PUBLIC HEARING/WORKING SESSION MEMORANDUM

PETITION #273-24 and #274-24

329-331 River Street

Re: Special Permit – 329-331-335 River Street

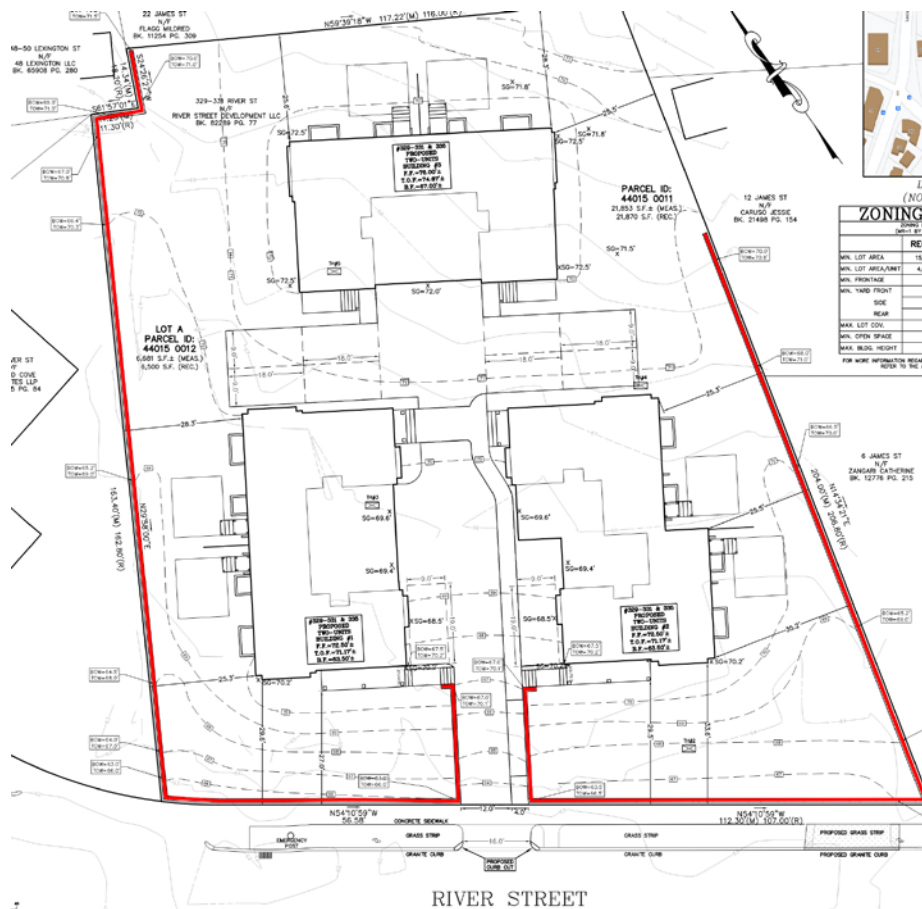
A retaining wall is proposed along the entire western property line, at the northwest corner the wall is 1.3-feet high and makes two 90° at which it becomes 3.8-feet high. This wall extends to River Street with an average height of 3.4'. A retaining wall is also proposed along the easterly property line this wall begins at River Street and extends northerly approximately 146 feet along the eastern property line. This wall's height at River Street is 4-feet, averages 3-feet high and terminates at 0.8 feet above current grade.

Along River Street a retaining wall is proposed from east to west with an opening for the proposed driveway. The wall is 4-feet high at the easterly corner and averages 3-feet towards the driveway opening. The western corner of this wall is at 3-feet above sidewalk grade and averages 3-feet up to the driveway opening.

The heavy red line around the perimeter depicts the proposed retaining wall limits. In reading the various top & bottom proposed elevations of wall it is clear that the site is being raised from its natural existing state. The updated plan also has eliminated the two parking stall that were near the front portion of the accesses driveway.

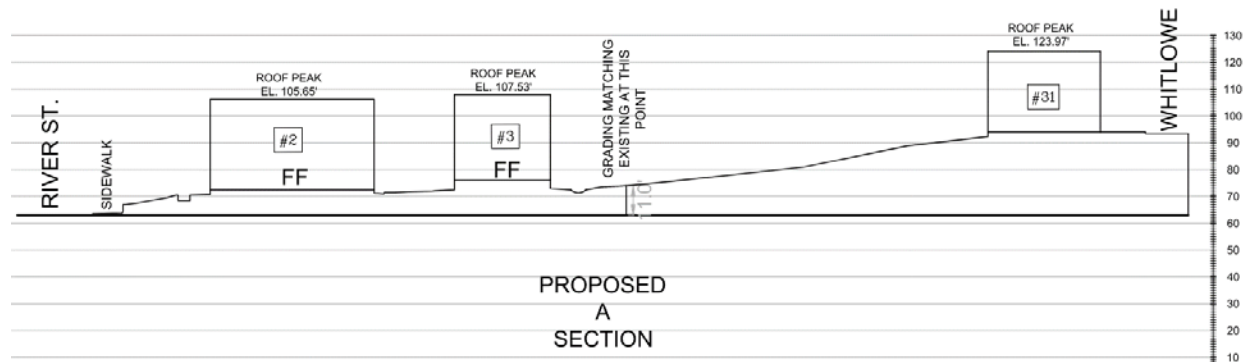
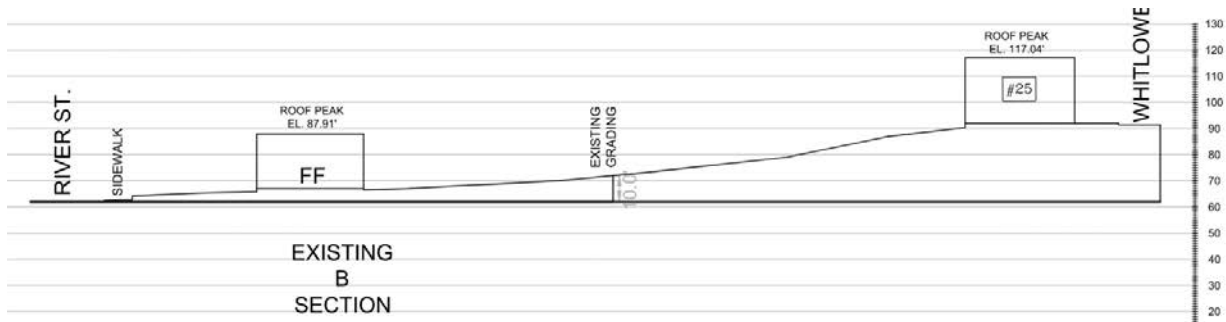
The applicant has also provided site cross-sections of existing & proposed conditions. On sheet 1 of 3 has sections A & B which shows the peak roof elevations of the two existing dwellings and the properties at #25 & 31 Whitlowe Road.

Sheet 2 of 3 shows the same cross-sections but with the proposed buildings 1, 2, and 3 and again #25 & 31 Whitlowe Road. The existing & proposed sections shown below indicates that the existing #25 Whitlowe Road home's peak elevation 117.04' and #31 Whitlowe Road is at 123.97'.

For the proposed conditions units 2 & 3 have roof peak elevations of 105.65' & 107.53' respectively and are 18.32' & 16.44' below the peak roof elevation at #31 at 123.97'.

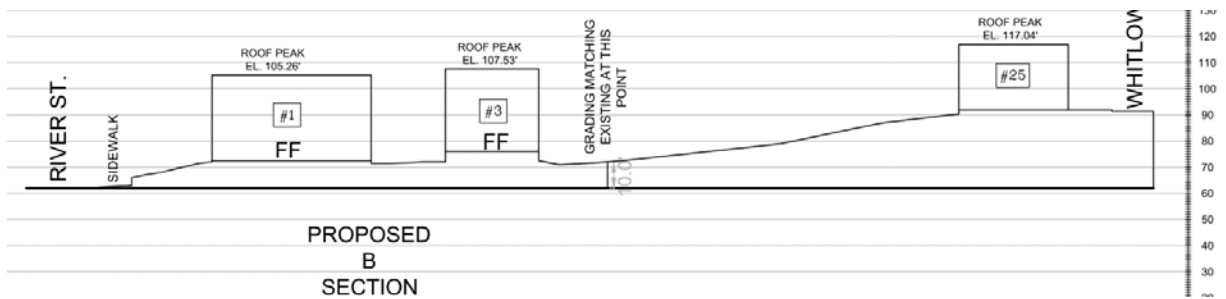
For the proposed conditions units 1 & 3 have roof peak elevations of 105.65' & 107.53' respectively and are 11.78' & 9.51' below the peak roof elevation at #25 at 117.04'.

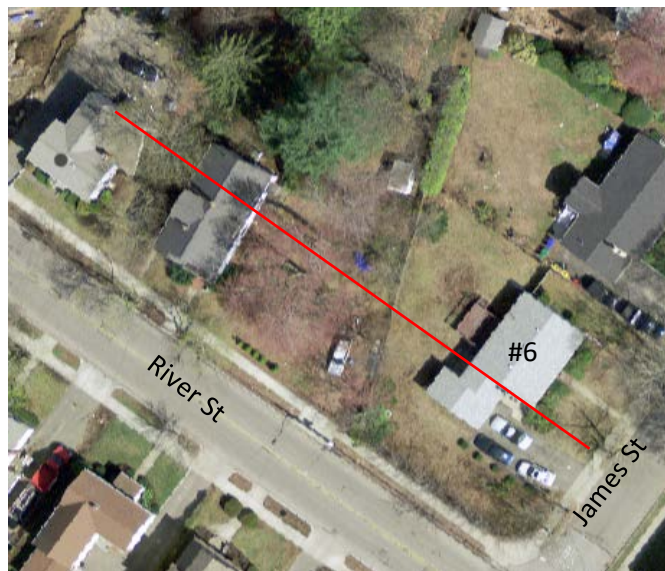
Sheet 3 simply shows a side-by-side comparison of both sections. A third site section should have been taken to show both existing and proposed conditions which would include the two new units 1& 2 and the existing home at #6 James Street.

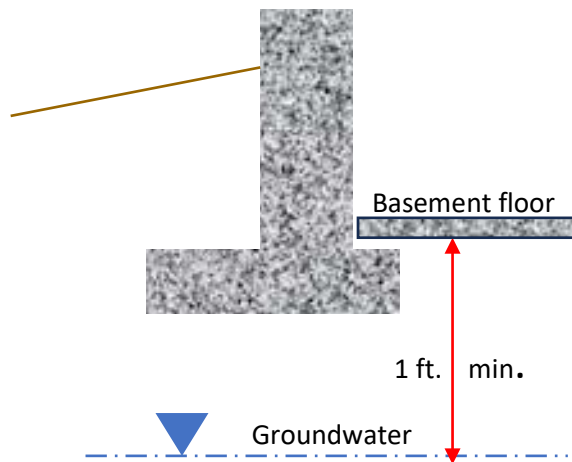
Groundwater depth varied throughout the site being the shallowest at test pit # 5 which is located within the proposed footprint of building # 3 towards the rear of the lot (See page 4 of 9 plan set).

The City Stormwater Ordinance requires a one (1-ft) separation between the underside of the basement slab and the seasonal high groundwater elevation. Additionally, a two (2-ft) separation is required between the bottom of the proposed infiltration system and the ground water. The design meets these requirements.
